Access Compliance Report Public Rights-of-Way (Curb Ramps)

Main Street: WILSON_ST Cross Street: WASHINGTON_AVE Location: NE

ADA ID: RPRK211001110937 Ramp Type: Type 1 - Perpendicular Diagonal Initial Pass/Fail: Pass Overall Compliance: No Severity Score: 4

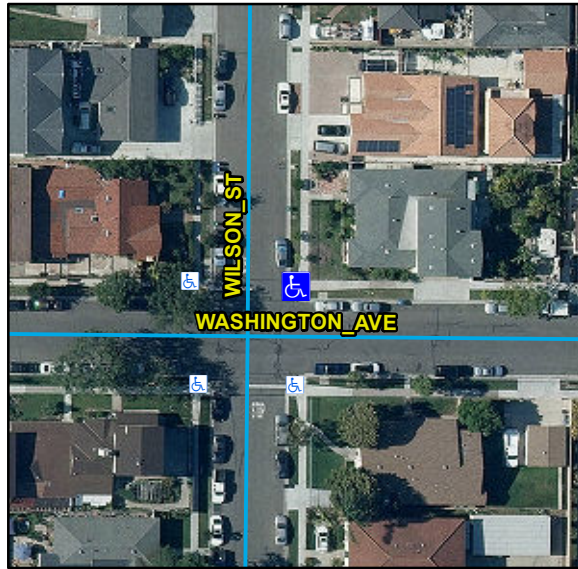
Compliance	Description	Data	Compliance	Description	Data
N/A	Ramp Length (in)	105	N/A	Flare Type LT	
Yes	Ramp Width (in)	48			Sloped
Yes	Ramp Run Slope (%)	4.2	N/A	Flare Slope LT (%)	2.5
Yes	Ramp Cross Slope (%)	0.5	N/A	Flare Traversable LT	No
N/A	Landing Present	Yes	N/A	Flare Type RT	
N/A	Landing Length (in)	45			Sloped
Yes	Landing Width (in)	48	N/A	Flare Slope RT (%)	6.7
Yes	Landing Run Slope (%)	1.4	N/A	Flare Traversable RT	No
Yes	Landing Cross Slope (%)	0.8	Yes	DWS Provided	Yes
N/A	Landing Movement Obstructed?	Yes	Yes	DWS Contrast	Yes
	Landing Movement Type	Curb	Yes	DWS Length (in)	36
N/A	Landing Shared	No	Yes	DWS Full Width	Yes
N/A	Clear Space	Yes	Yes	DWS Offset Left (in)	0
N/A	Clear Space To Crosswalk (in)	48	Yes	DWS Offset Right (in)	N/A
N/A	Marked Crosswalk 1	No	N/A	Marked Crosswalk 2	No
	Crossing 1 Direction	W		Crossing 2 Direction	S
	Marked Crosswalk 1 Width (in)	N/A		Marked Crosswalk 2 Width (in)	N/A

N/A	Ramp Inside Crosswalk 1	N/A	Yes	Ramp Inside Crosswalk 2	N/A
	Crossing 1 Slope (%)	5.2		Crossing 2 Slope (%)	1.2
	Crossing 1 Cross Slope (%)	3.2		Crossing 2 Cross Slope (%)	3.9
Yes	Gutter Ponding	No	No	Curb Slope	5.9
Yes	Gutter Lip Height (in)	0		Road Run Slope (%)	2.8
Yes	Gutter Run Slope (%)	3.5		Road Cross Slope (%)	1.1
No	Gutter Cross Slope (%)	3.5			
Yes	Overall Surface Condition: Acceptable		Yes	Perp Joint Present	Yes
	Cross Gutter Present?	No		Spandrel Present?	No
	Replace Cross Gutter?	N/A		Replace Spandrel?	N/A

Remove & Replace Curb Ramp With Two New Directional Ramps or Equivalent. Remove & Replace Gutter.

R304.2.2, R304.2.1, R304.5.3, STD 1115
